Item Name: Replacement Skidtube, Low & High Gear with Standard Wearplates Fits LH or RH

D2650-1 BENDING/DRILLING DETAIL

DRAWING NO. D2650	TITLE 206/407 SKIDTUBE ASSEMBLIES	REV. F	DART AEROSPACE LTD ENGINEERING ORDER		D.E.O. NO. D2650-F-1	SHEET NO. SHEET 1 OF 1	SCALE NTS
DRAWN <i>JP</i>	CHECKED <i>A.P.</i>	MFG. APPR. <i>DA</i>	APPROVED <i>TH</i>		DE APPR. <i>TH</i>		
DATE 12.10.12	DATE 12.10.22	DATE 12.10.22	DATE 12.10.22		DATE 12.10.22

CHANGE C'BORED WELDED CROSSBOLT SPACERS TO SWAGED SPACERS

DETAIL B

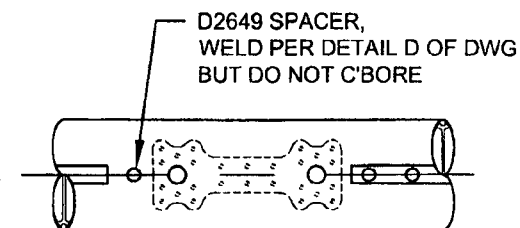
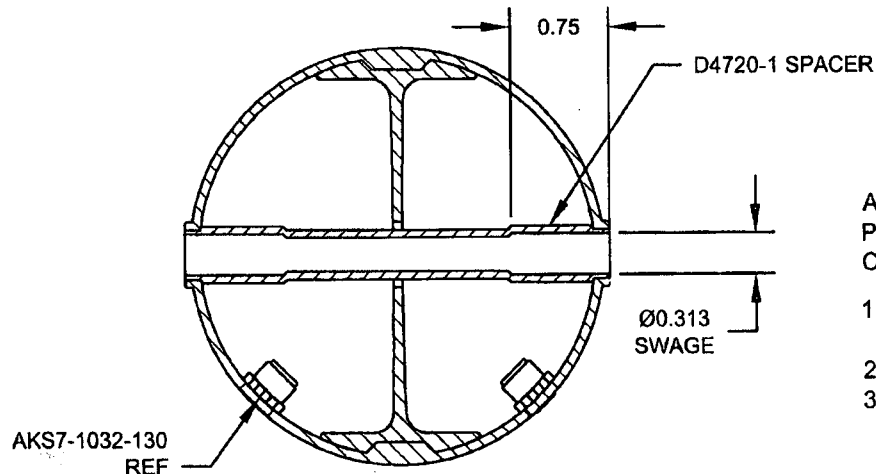
ADD DETAIL G BELOW, WHICH IS THE SAME SECTION VIEW AS DETAIL D OF DWG.

C'BORED HOLES ARE NOW SWAGED PER DETAIL G BELOW. FOR THE Ø0.375 HOLE THAT IS NOT C'BORED, WELD PER DETAIL D OF DWG (SEE AMENDED DETAIL B FOR REFERENCE).

AMENDMENT TO DETAIL B
NOT TO SCALE
